## ADDENDUM

**PROJECT:** State of Nebraska  
Grand Island Veteran's Home  
WWII / Phillips Building  
Mechanical, Electrical, and ADA Upgrades  
Grand Island, Nebraska

AD-3

**DATE ISSUED:** Thursday, January 26, 2012

| G-104.1   |             |

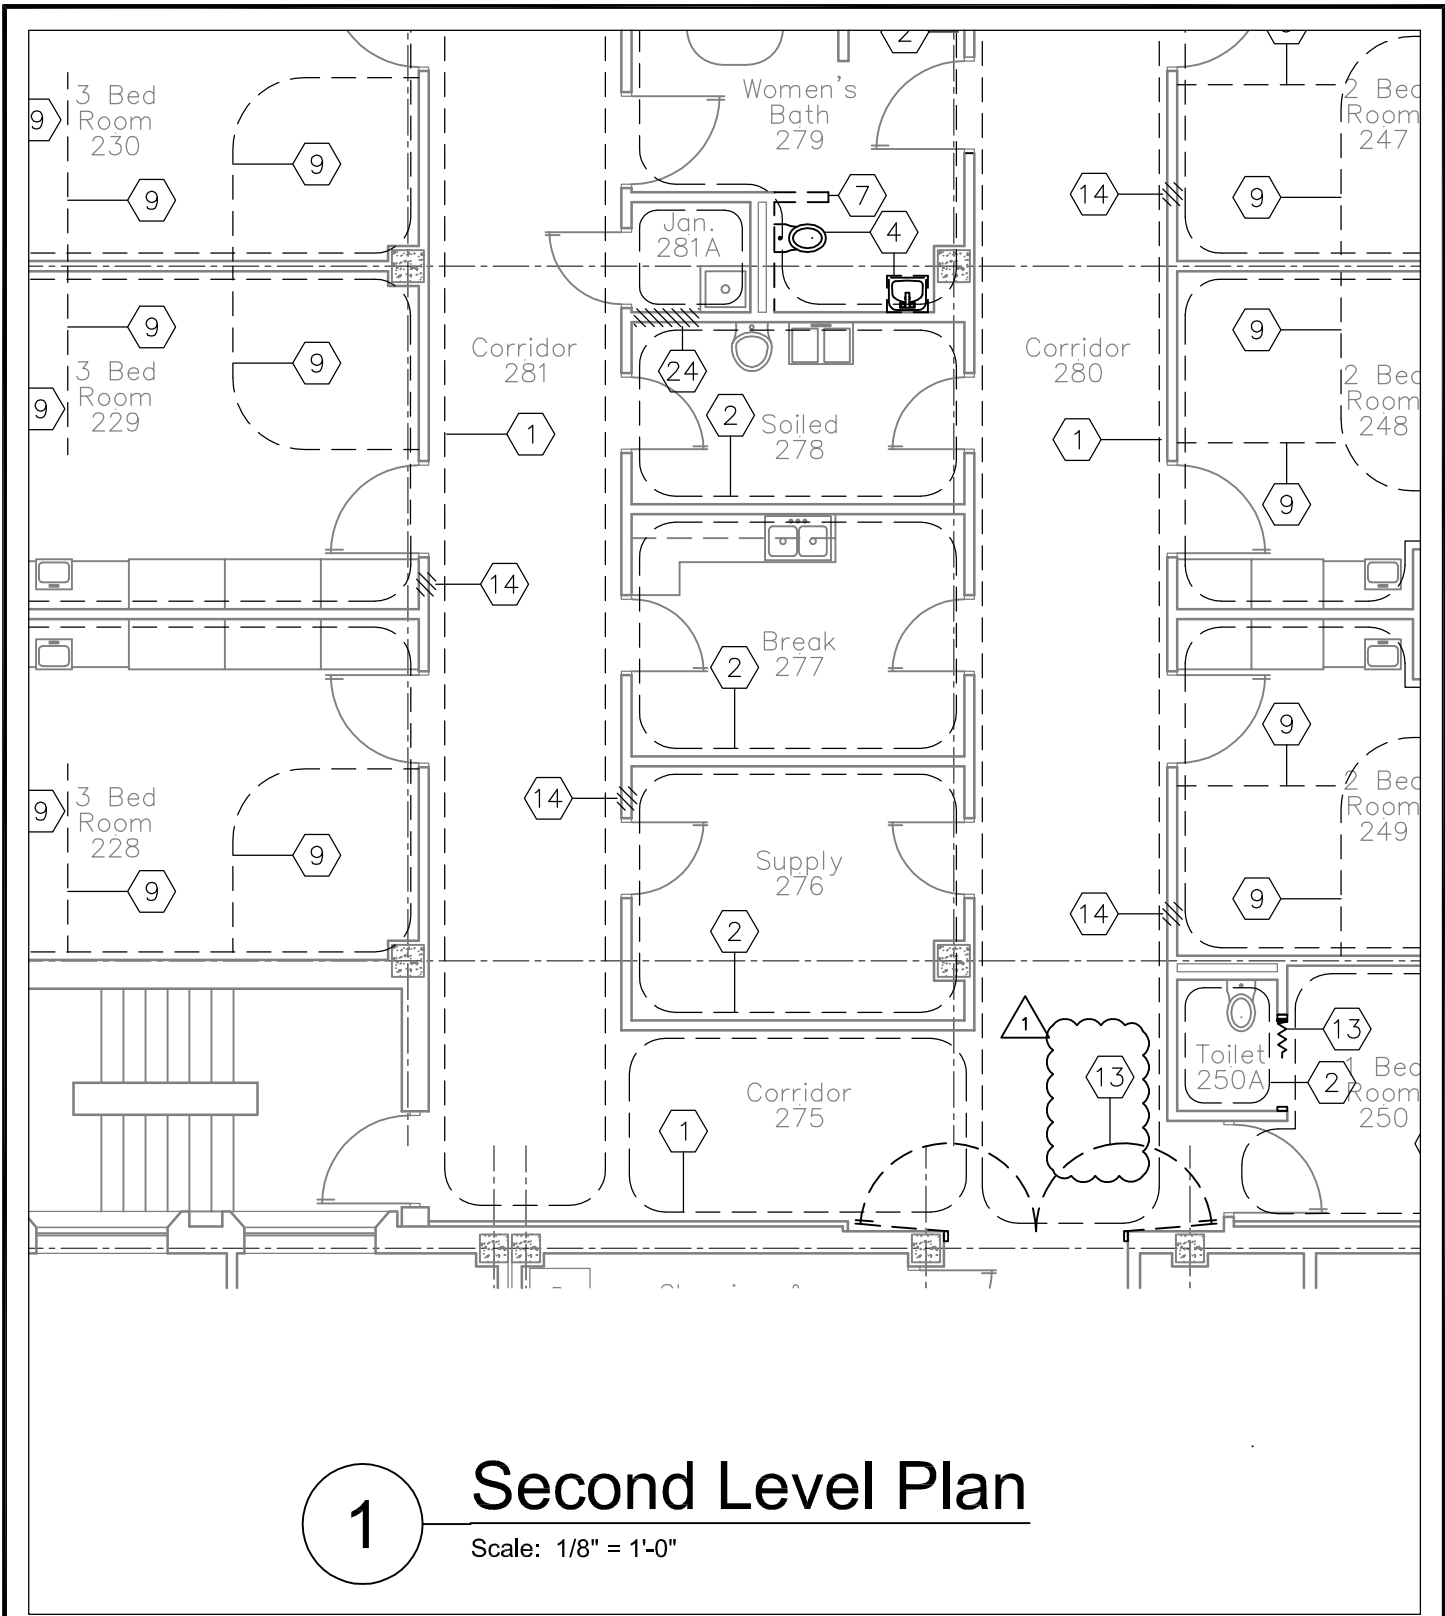
**In reference to drawing G-104 and G-105,** refer to drawing G-104.1 for correct Separations Legend and modification of 1-Hour Rated Smoke Barrier into a 2-Hour Rated Smoke Barrier

2-HOUR RATED SMOKE BARRIER  
(2 HOUR FIRE RATED AND RESTRICT MOVEMENT OF SMOKE)

| Drawing #                                    | A-105.1 |                        |            |

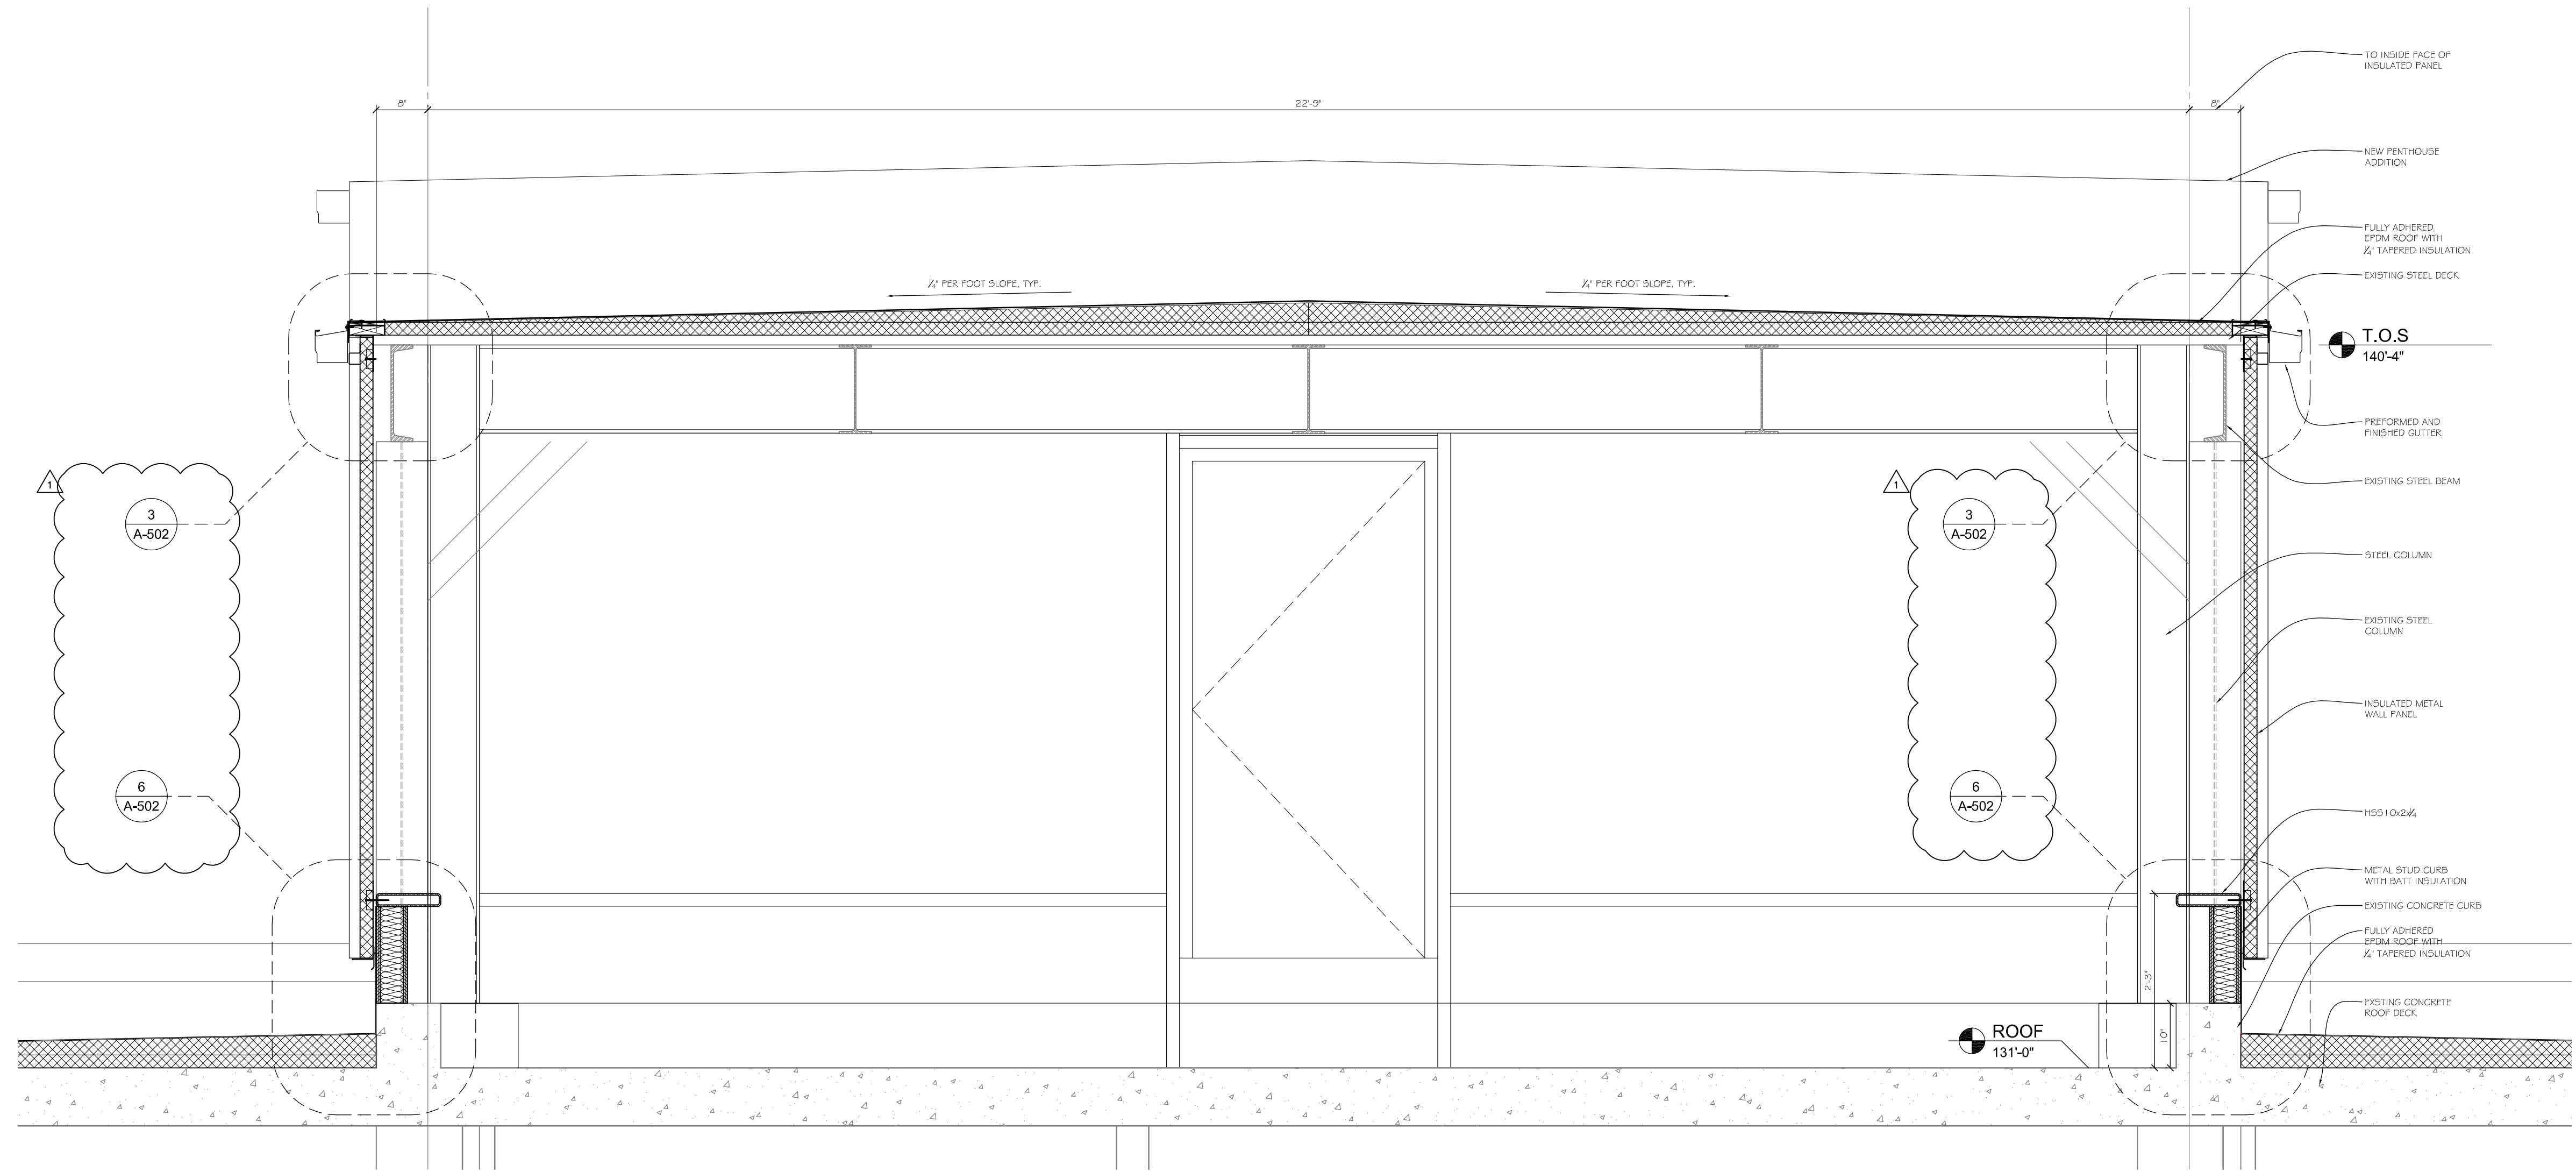
**In reference to drawing A-102, A-103, A-104, & A-105,** refer to attached drawing A-105.1 for Smoke Barrier partition type modification.
